HISTORIC AND DESIGN REVIEW COMMISSION

HDRC CASE NO: 2015-192
ADDRESS: 3903 N ST MARYS
ZONING: R6 HS RIO-1
CITY COUNCIL DIST.: 2
LANDMARK: Brackenridge Park
APPLICANT: Tim Morrow
OWNER: City of San Antonio / Parks Department
TYPE OF WORK: San Antonio Zoo Giraffe Exhibit
REQUEST:

Revise the existing hoofstock exhibit into a mixed hoofstock and giraffe exhibit, including regrading the site to be giraffe friendly. To achieve the giraffe friendly grades, the pond and some landscape islands are to be removed as well as the existing, non historic barn. Existing landscape islands that remain will be encased in a smooth coat of rockwork for animal welfare. A new pond will be constructed as well as a wood screen fence that will be constructed at a taller height.

F5 FENCE AND GATE TYPE F4

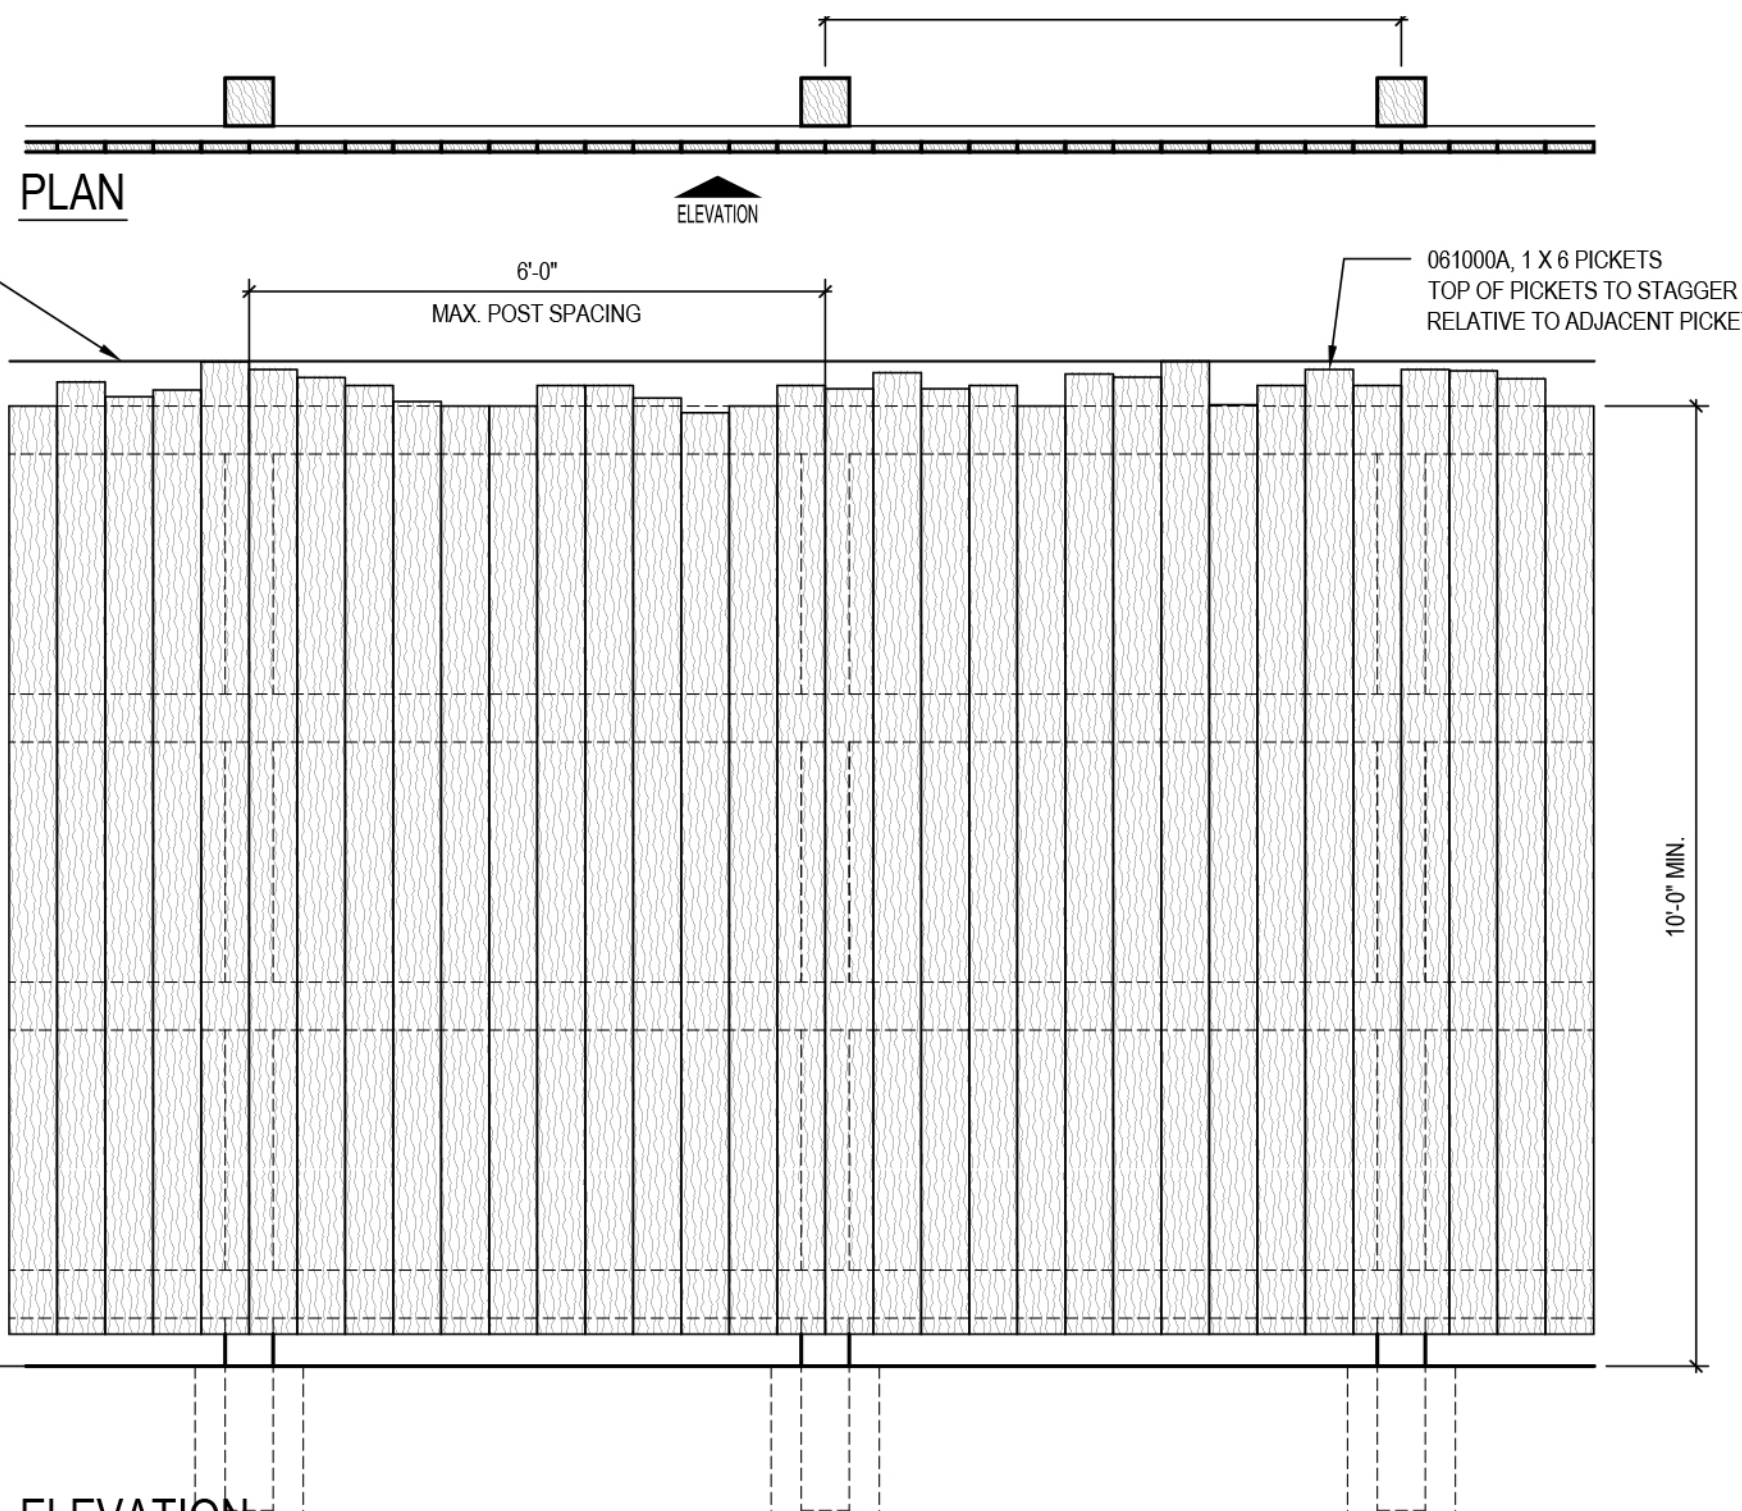
- c. The applicant has proposed to remove the existing wood screen fence in the proposed giraffe exhibit and rebuilt a taller food fence at the pedestrian bridge for a giraffe barrier. The applicant has proposed to reconstruct the new wood screen fence to match the materials of the existing. This is consistent with the Guidelines for Site Elements 2.B.i.

Staff recommends approval as submitted based on findings a through d.

Photo 11: North Giraffe Barn – Demolish barn and fence posts due to rot, salvage roof structure

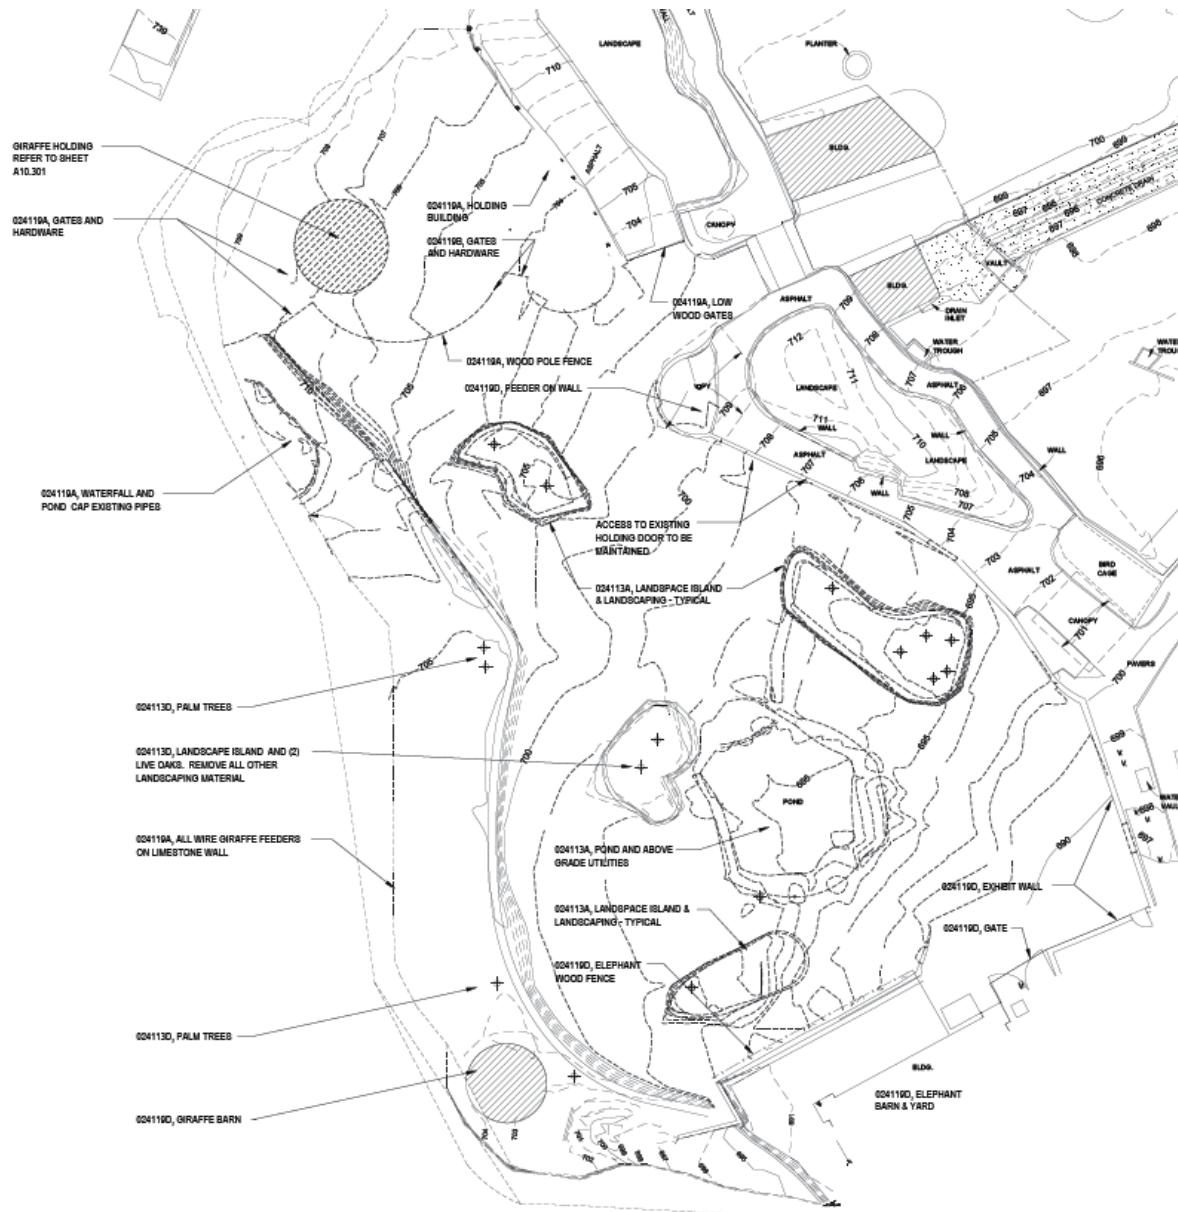
- d. The applicant has proposed to demolish the existing, non historic barn due to wood rot. Within this demolition, the applicant has proposed to salvage the existing roof structure. Staff finds that the demolition of this non original element as well as the salvaging of the existing roof structure is appropriate.

Site Demolition Plan

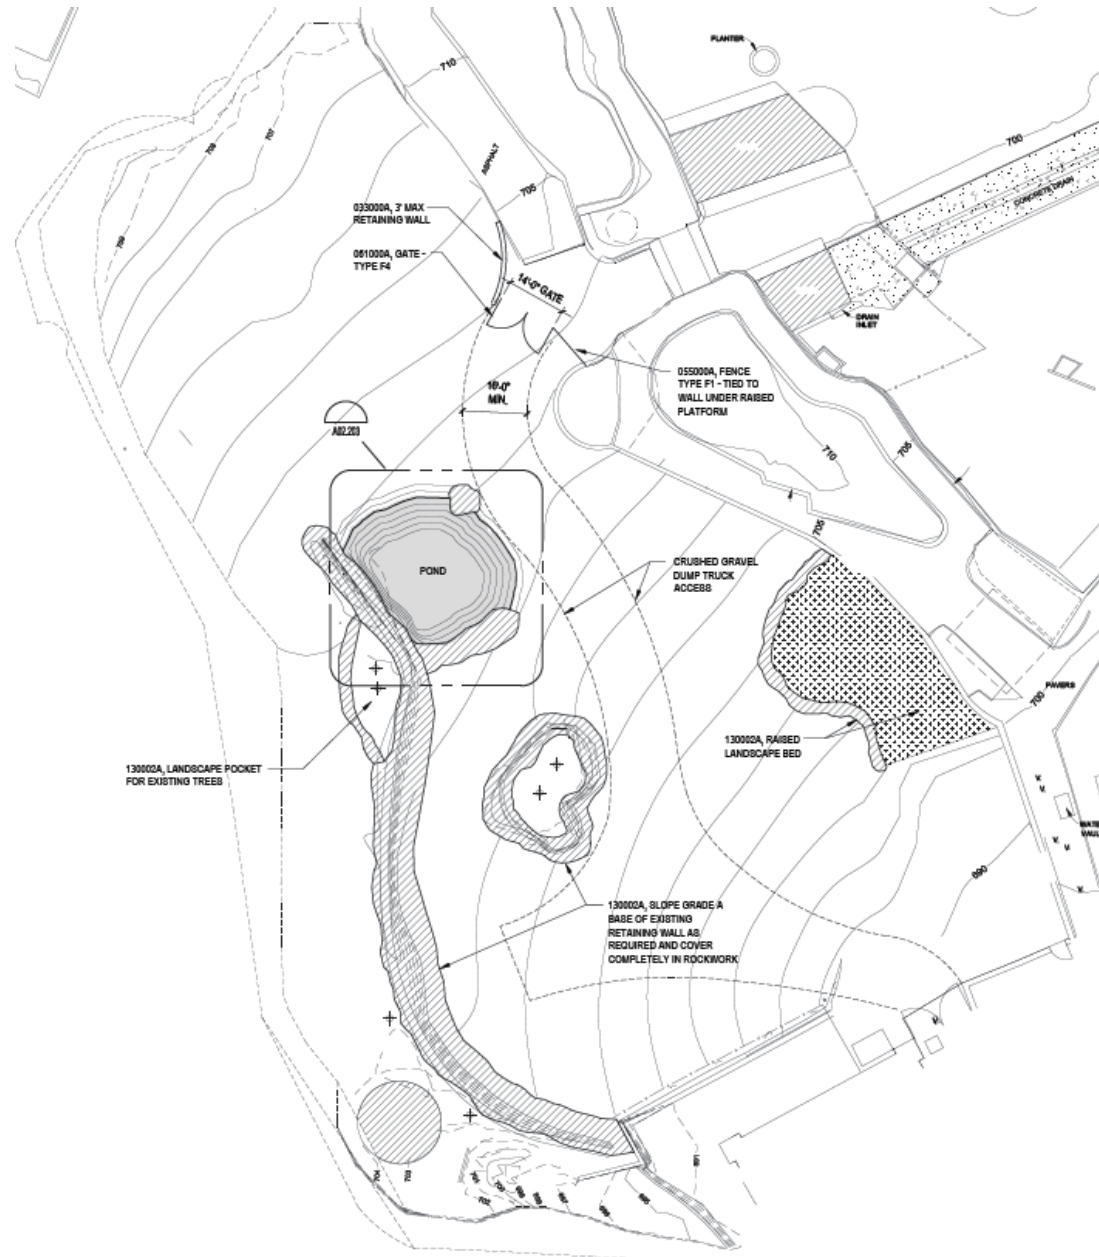
- a. In order to accommodate a giraffe exhibit at the San Antonio Zoo, the applicant has proposed to remove three existing landscaping islands. Within these existing landscaping islands are a variety of trees including Palm trees and Mesquite. The Palms range from 13" to 15" in diameter and the Mesquite range from 10" to 16" in diameter. These landscaping islands are each approximately 3' tall and are constructed of stone similar to the stone featured in the WPA walls, however the WPA era historic walls are not to be impacted by the removal of the landscaping islands. The remaining landscaping islands will be coated with a smooth rock surface to accommodate the giraffe. This is consistent with the UDC Section 35-642(a) regarding Site and Setting.

- b. Along with the removal of three non original landscaping islands, the applicant has proposed to re-grade the site to accommodate the giraffe and construct a new pond. The applicant has noted that the regrading activities will not damage the WPA era walls and will slope away from the walls. This is consistent with the Secretary of the Interior's Standards for Rehabilitation numbers 9 and 10.
